Subject: Applicant's Response to Data Requests, Set 2B (#173-185)
Rio Mesa Solar Electric Generating Facility (11-AFC-04)

Applicant's Response to Data Requests, Set 2B (Nos. 173-185)

**Rio Mesa Solar Electric
Generating Facility
(Rio Mesa SEGF)**

(11-AFC-04)

Attachment DR 180-1

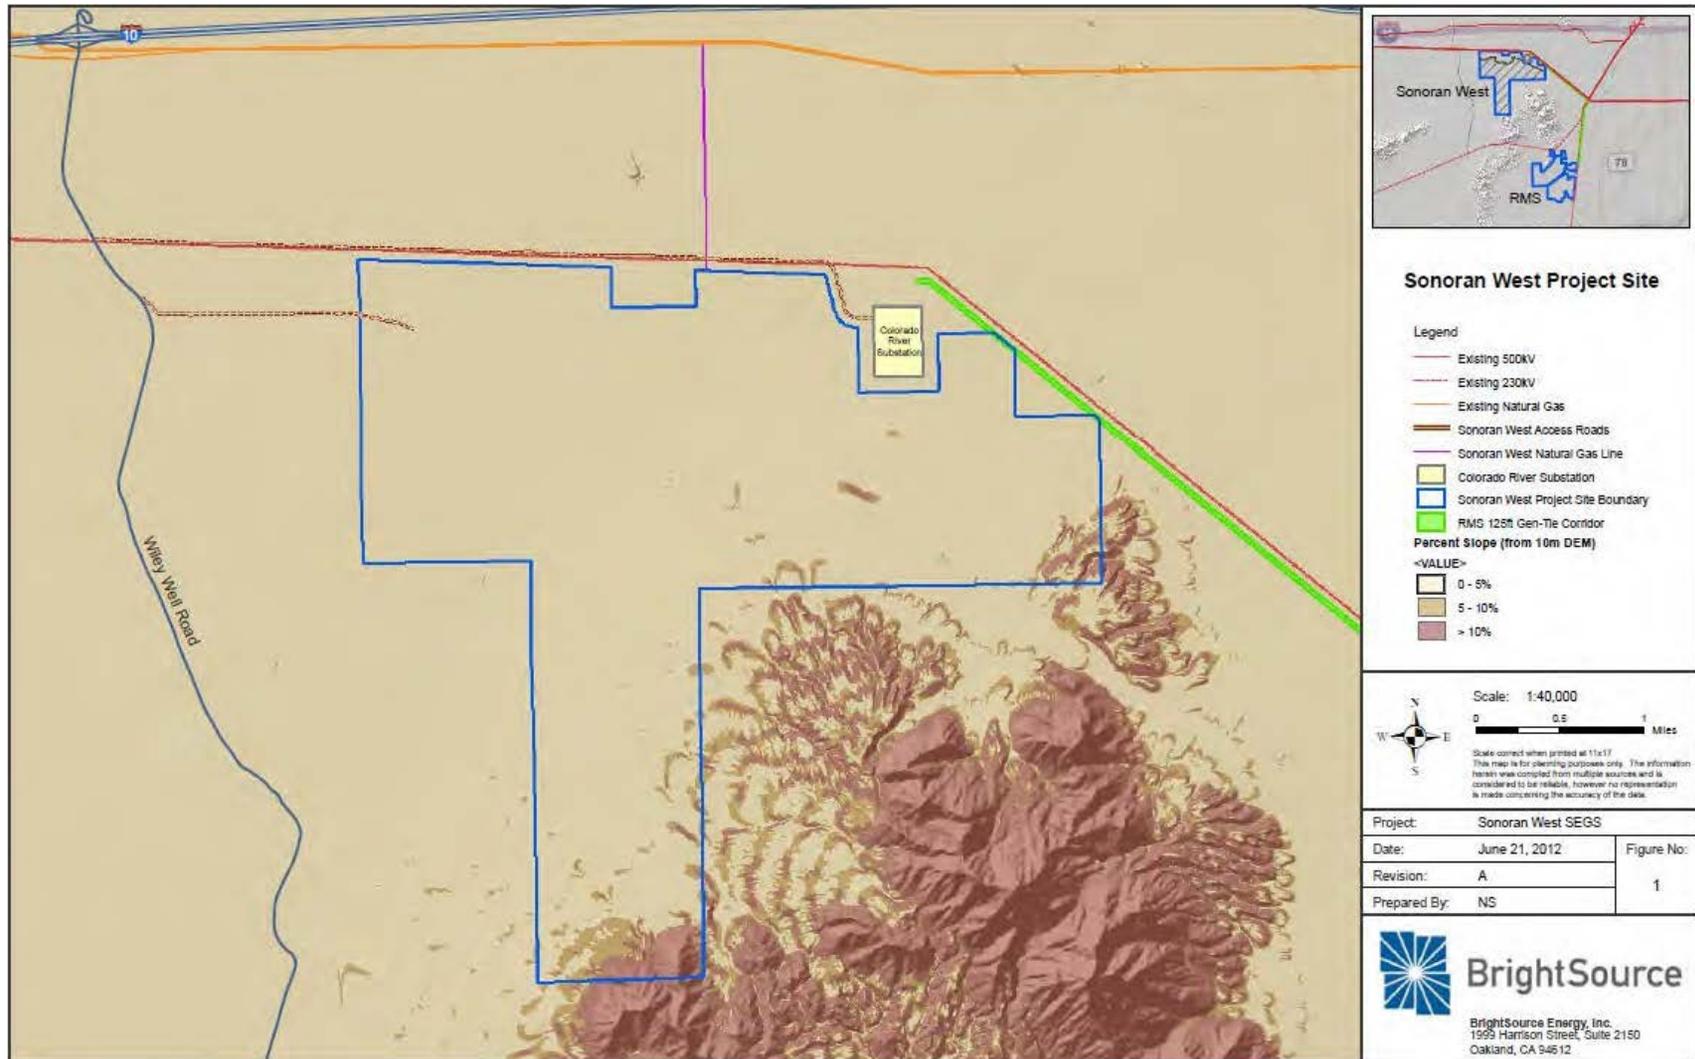
- a. Information on the slope of the alternative site. Include shape files of the site boundaries and a map showing a possible project site and footprint. Describe the topography and elevations in the areas;

- b. Information on the site access from public roads in the area;
- c. Please provide a detailed map showing the route for a transmission line interconnection at the Colorado River Substation. Estimate a cost for the generation tie line to the Colorado River Substation and compare those costs to the known or estimated transmission costs for the Rio Mesa SEGF project;

- c. Please provide a detailed map showing the route for a transmission line interconnection at the Colorado River Substation. Estimate a cost for the generation tie line to the Colorado River Substation and compare those costs to the known or estimated transmission costs for the Rio Mesa SEGF project;

- Site boundaries & Project footprint: (See “Attachment DR 180-1”)
 - Topography & Slope: (See “Attachment DR 180-1” for further illustration of slope).

- o In general the site is characterized by a very flat (less than 5 percent slope) northeasterly draining watershed.
- b. Information on the site access from public roads in the area.

- Public Road Access: (See “Attachment DR 180-1”)
 - o The primary and secondary access roads to the site are existing public roads (Powerline Road) and/or OHV trails (trail extending south and parallel to Powerline Road). Both existing access roads extend east from the Wiley Well Road (see Attachment DR 180-1”).

- Transmission Interconnection at the Colorado River Substation: (See “Attachment DR 180-1”)
 - o A Generation tie line between the proposed Sonoran West Switchyard and the Colorado River Substation is not anticipated to be necessary due to its location immediately adjacent to the existing substation.

- o The lack of gen-tie facilities in the proposed Sonoran West Project layout implies that these facilities will have zero cost to the project.
- d. Information and a map showing a potential connection to a gas pipeline in the vicinity;

- Natural Gas Interconnection for Sonoran West: (See “Attachment DR 180-1”)
 - o The proposed natural gas interconnection line spans a distance of approximately 1 mile to the proposed interconnection point to existing Southern California Edison natural gas pipelines running parallel to Hwy 10.

Attachment DR 180-2

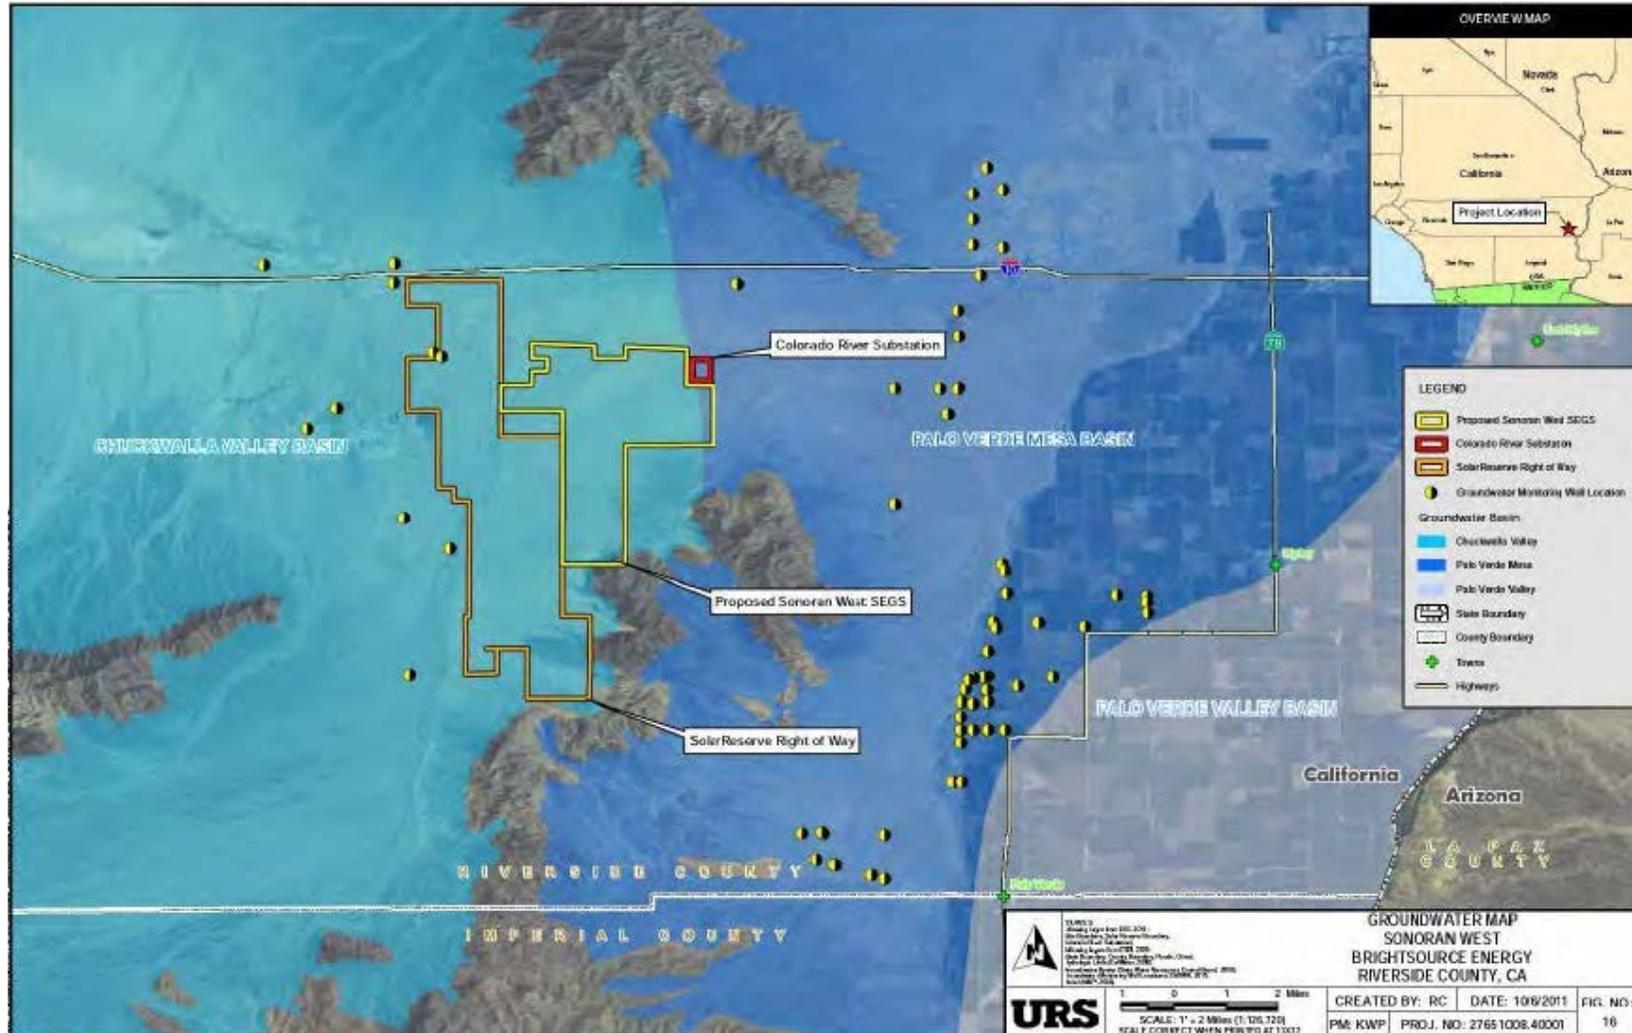
- d. Information and a map showing a potential connection to a gas pipeline in the vicinity;
- e. Details on the individual water supply wells in the area, including the number of wells and current uses. Discuss any water allocations for agricultural use, and identify the potential source(s) of water for this alternative;

- Water wells located in the vicinity of Sonoran West: (See “Attachment DR 180-2”)
 - o There are no existing waterwells located within the proposed project boundary of the Sonoran West Solar site. (See “Attachment DR 180-2”)

- o There are approximately 4-5 existing water wells within a 2 mile radius of the proposed Sonoran West Project Site. (See “Attachment DR 180-2”)
 - o There is no existing agricultural land usage within the immediate vicinity of the Sonoran West Project. The applicant has no data pertaining to the existing water rights or water well usage in the area.

Attachment DR 180-3

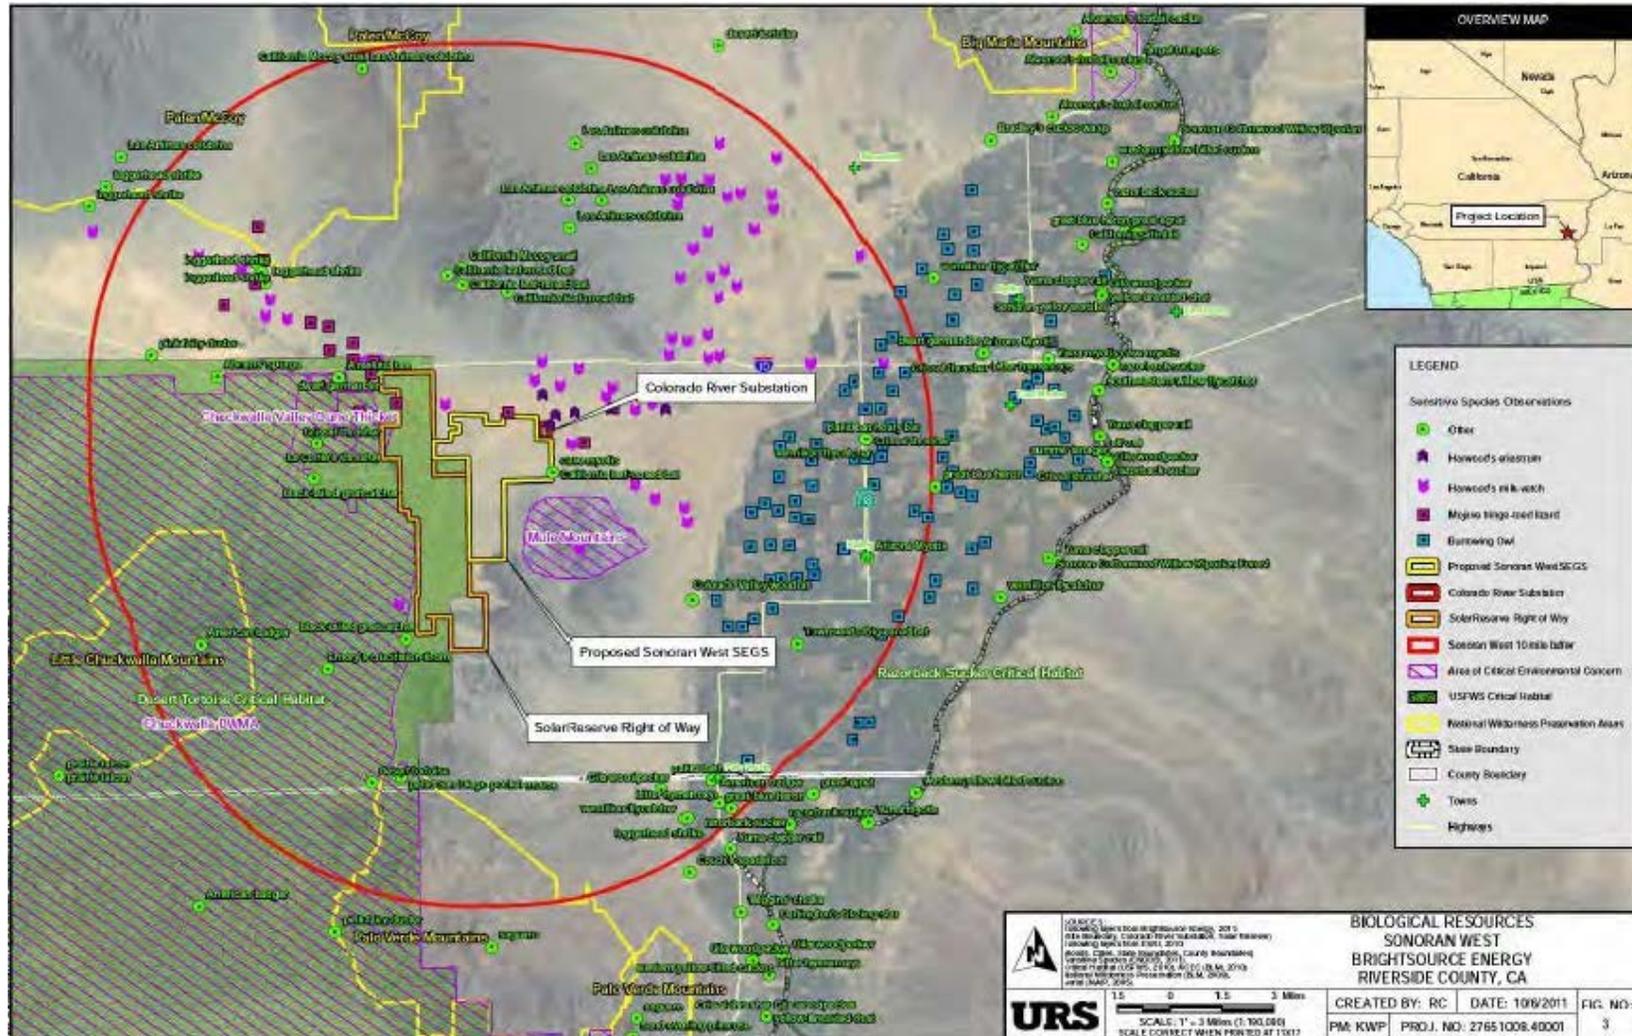
- f. Information on habitat types and protected plant and wildlife species that could be present in the area. Include data obtained from a California Natural Diversity Database (CNDDDB) record search for the area, and a map illustrating CNDDDB data and distribution;

- Sonoran West Habitat Types and Protected Plant & Wildlife Species potentially occurring in the area: (See “Attachment DR 180-3” for known CNDDDB data)

Attachment DR 180-4

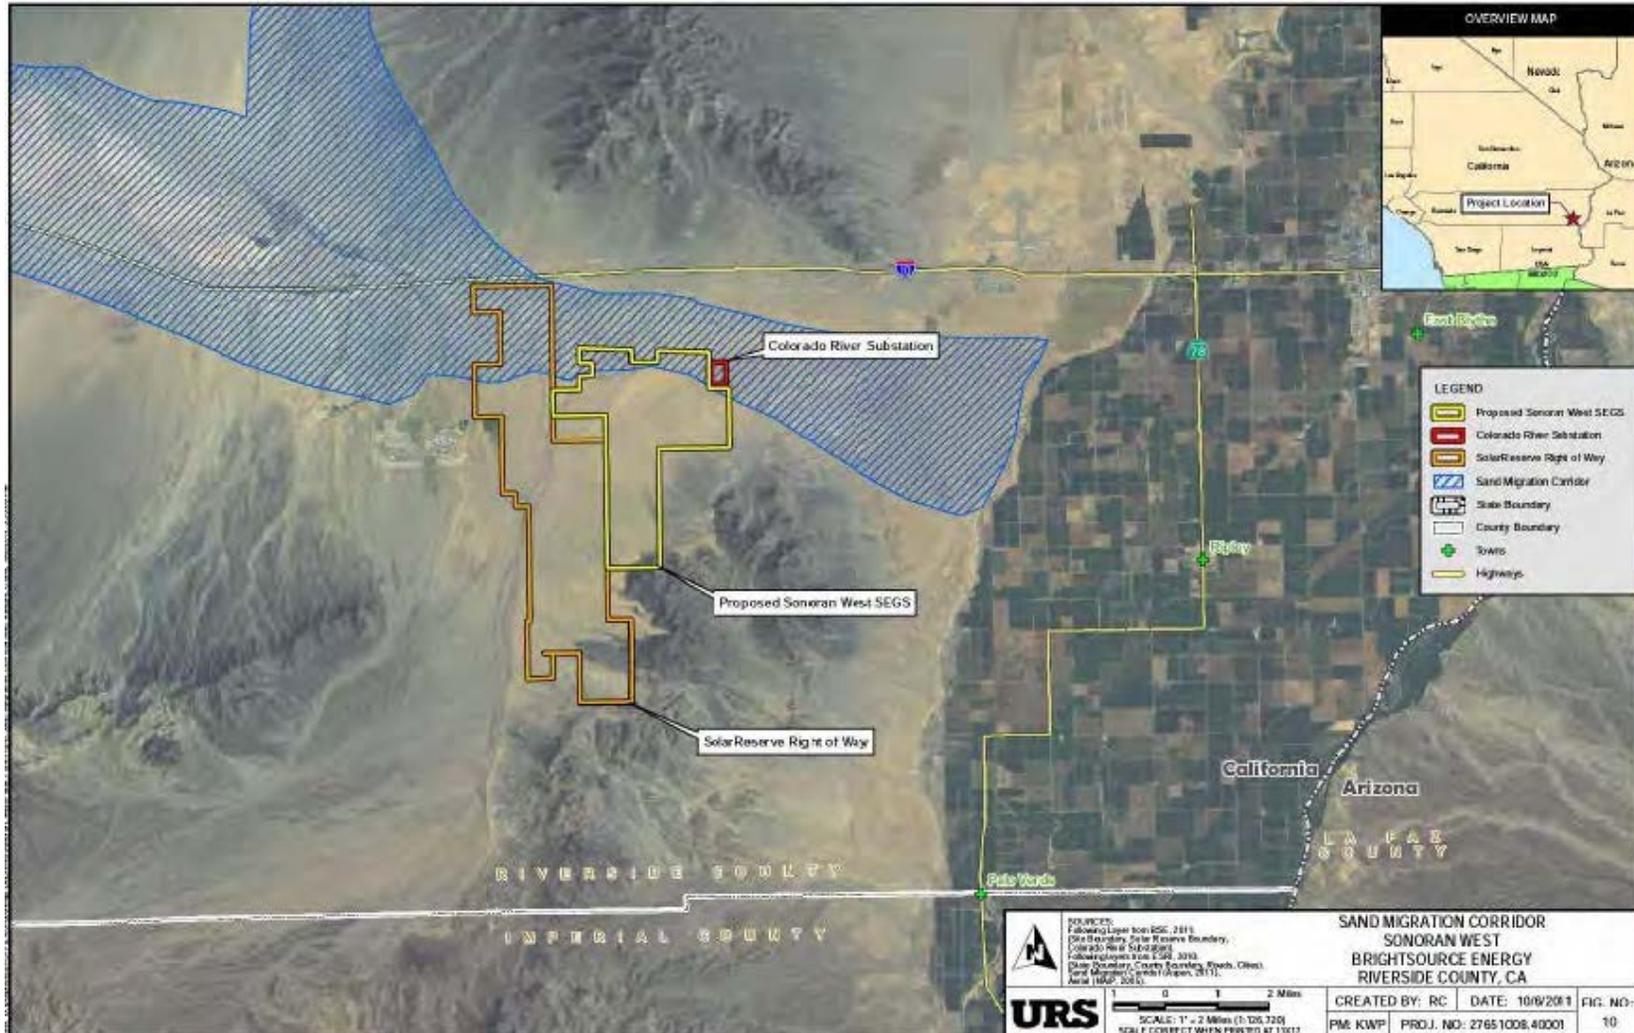
- f. Information on habitat types and protected plant and wildlife species that could be present in the area. Include data obtained from a California Natural Diversity Database (CNDDDB) record search for the area, and a map illustrating CNDDDB data and distribution.

- o Mohave Fringe Toed Lizard habitat is known to potentially occur in areas (sand corridors) located within the northernmost portion of the project area. (See “Attachment DR 180-4”)
